MCPB Item No. 5

Date: 07/19/18

7607 Old Georgetown Road, Sketch Plan No. 320180160

Figure 6: Vehicular & Pedestrian Circulation

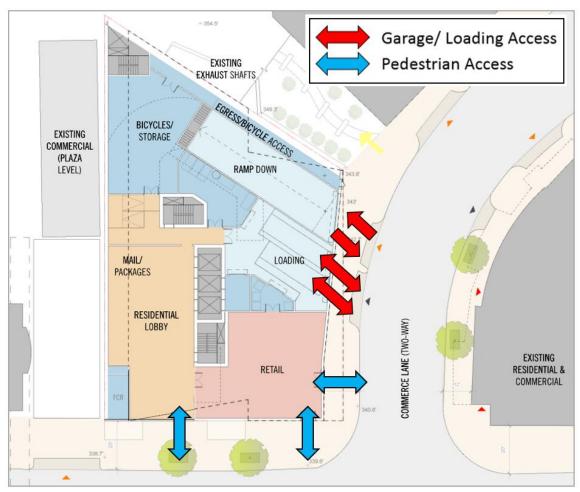
Vehicular access to the Property is proposed directly from Commerce Lane through a consolidated garage access point and loading bay (two separate but adjacent entrances) at the northeast corner of the site. This configuration eliminates vehicular access from Old Georgetown Road (MD 187) and minimizes interuptions to the pedestrian realm.

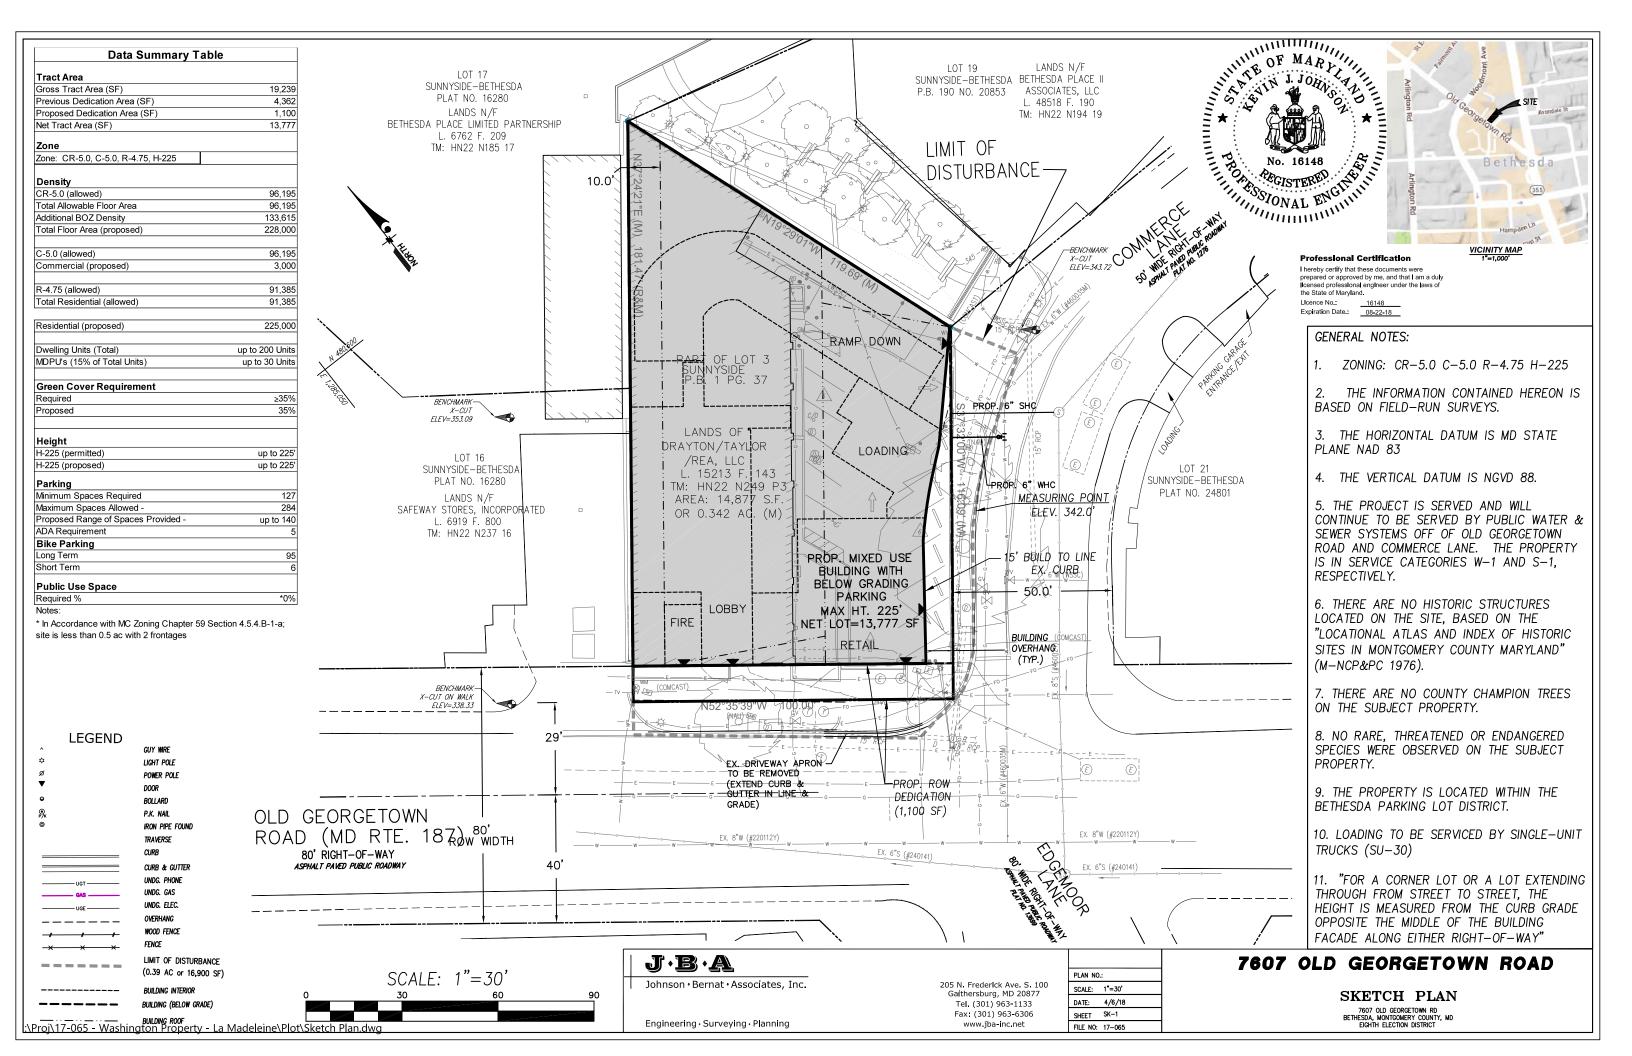
- Public Comments:
 - Really like the massing but have a few functional design concerns. The entrance to Bethesda Place is very narrow, how will the new entrance compare to that? Right now, Bethesda Place Plaza is a failed space, are you coordinating with the owners?

- Would like to see more detail on the interplay with Bethesda Place Plaza and what can be done to improve the visual impact of the loading areas.
- No public realm on your project particularly because of the size of the site.

- Moving the curb cut helps a lot and improves Old Georgetown Road for pedestrians.
- For the impossible site you are giving an excellent resolution.
- The angle of loading docks might serve better if further south and change the angle.

- Applicant response: Yes, we are coordinating with the owners, and are looking at how to access Bethesda place
 - Loading on commerce, when loading is difficult or on a narrow street, they will likely just block the street and block traffic.

- Applicant response: We will explore this.
- What is the elevation of Bethesda place compared to the building? What is the publicness
 of the connection to the Bethesda Place Plaza?
